INSPECTION SUMMARY LETTER

KPRG Project No. 16005

Re: Liner Inspection -- West and East Ash Pond at the Waukegan Generation Station

Photo 3. West Pond, Center Berm, West Wall. Note anchor trench settling.

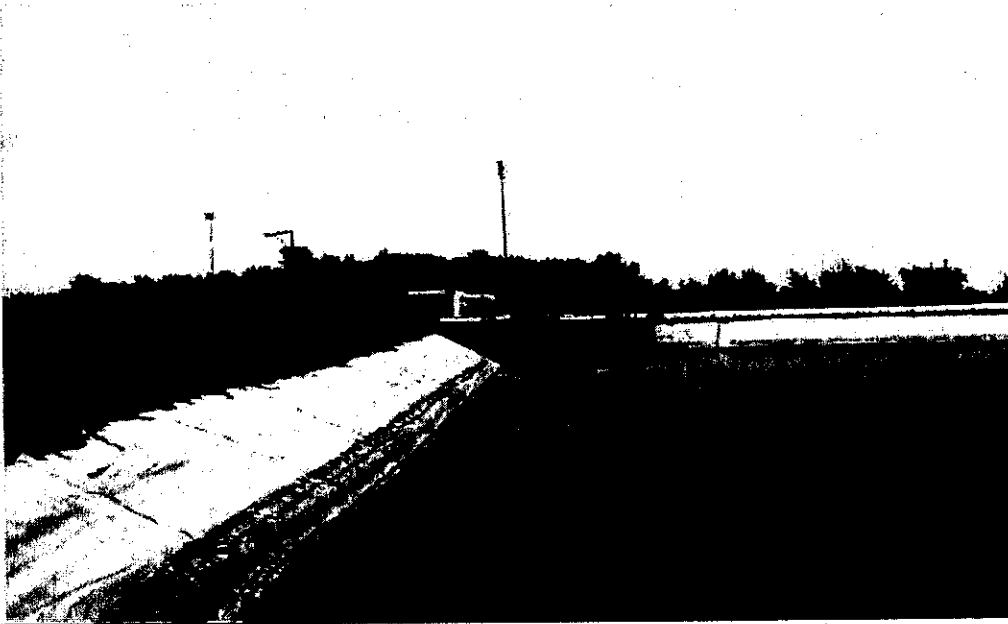
- 5) There is some evidence that the anchor trenches may have settled at the top of the slope. This settling can occur when the anchor trench backfill material is not compacted sufficiently (Photos 3, 4 and 22). This settling appears more prevalent on the west pond anchor trenches than on the east pond. Currently the settling is aesthetic issue only and may actually contribute to the wrinkles on the west pond slopes; however, periodic visual monitoring of the anchor trenches is needed to ensure there is no additional settling.

Photo 4. West Pond, Center Berm, East Wall. Note anchor trench settling.

- Perform regular inspections (semi-annual) of the anchor trench, particularly on the West Pond, to monitor any additional settling that may occur.
- Future design considerations should include a geotextile between the sand base and overlying crushed limestone to preclude aggregate migration through the sand due to pressure (i.e., from equipment traffic during pond clean out) which may cause the aggregate to be in direct contact with the underlying liner. Other protective base materials such as fabric form concrete can also be considered.

Photo 8. West Pond, Sump. Note missing vertical batten.

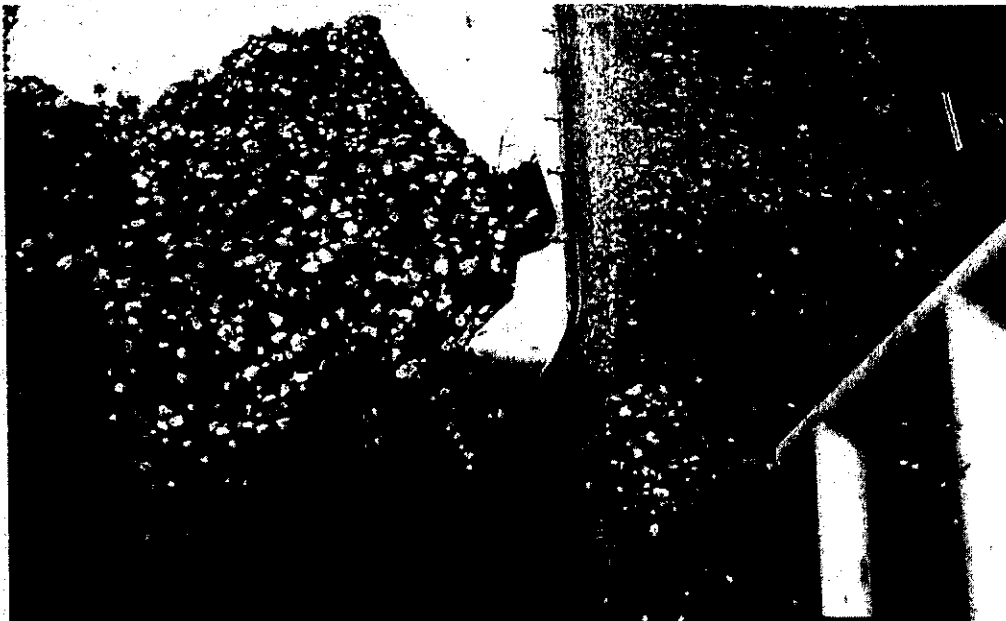
At the sump structures the new batten, however, should have been extended below the finish grade at the anchor trench location prevent erosion from rain water flowing under the liner of the slope next to the concrete sump structures (Photos 8, 9, and 10 – batten stopped short of finish grade). Adjoining pieces of batten should also be butted together to prevent gapping and subsequent leakage. The batten was not aligned or butted together at the change in plane on the sloped portion of the weir wall of the east pond sump (Photo 12).

Photo 10. West Pond, Sump. Note missing vertical batten and evidence of water erosion on back side of liner.

- Have the liner breach noted in Item 7 above repaired by the installation contractor (it is our understanding that this is already being scheduled).
- During the above noted liner repair, have the contractor extend vertical battens near the structure on the north side of the ponds to below grade at the anchor trenches. Also repair the seam issue noted in Item 8 above.

Photo 16. East Pond.

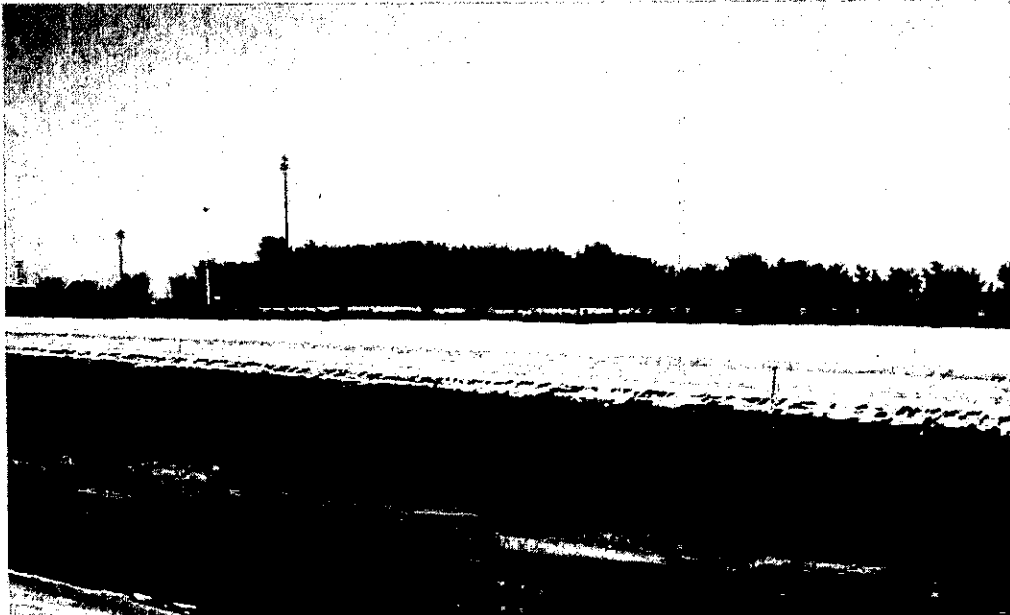
- 3) Installation of HDPE liner during hot weather must include deploying excess material to compensate for the thermal contraction which takes place as the temperature decreases. This excess material is evident as wrinkles in the liner. The wrinkles associated with HDPE Liner are an aesthetic issue only. A liner that is installed without enough excess material may result in tension across the liner seams which can produce stress cracks at seams and/or may pull the liner away from mechanical attachment points or out of the perimeter anchor trench. Based on our research and experience, the liner wrinkles in the east and west pond liners are consistent with similar projects using 60 mil white on black HDPE liner. The wrinkles in the West Pond are probably exacerbated by the having the lower portion of the slope liner loaded with ash and may be isolated to the exposed top portion of the slope liner (refer to Photo 3 for typical wrinkling noted on the exposed liner for the West Pond). This isolation may cause a greater frequency and amplitude in the wrinkles. Please compare the wrinkles in east pond with and without an ash load on the lower portion of the slope (Photos 16 and 20, respectively).

Photo 21. West Pond. Note unrepaired test seam cut.

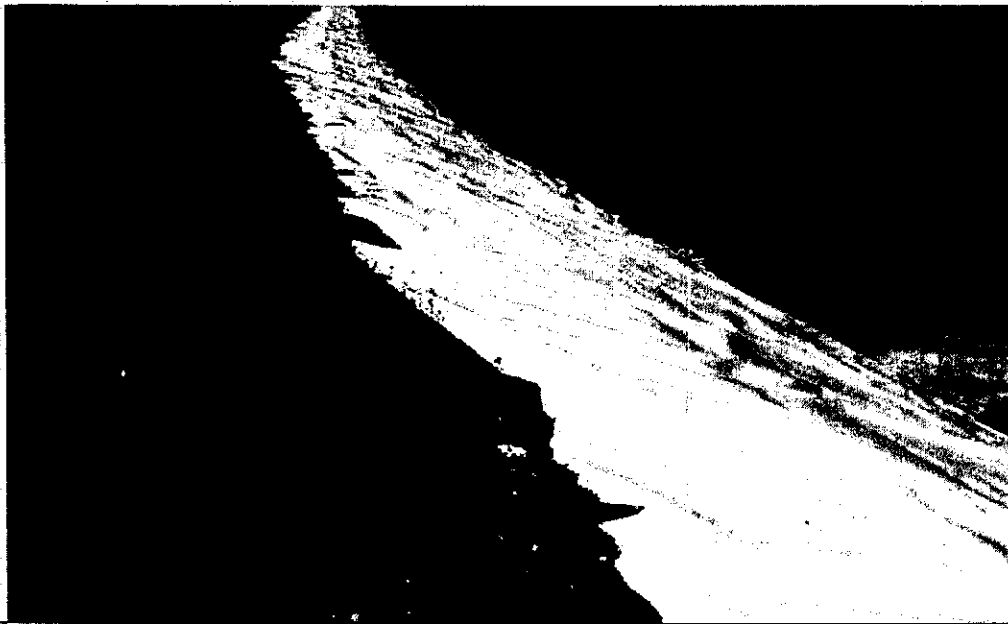
- 8) A wedge weld pressure test seam cut in the southwest corner of the West Pond was not patched (Photo 21). This does not constitute a breach of the main portion of the liner but should be addressed by the repair crew when on site.
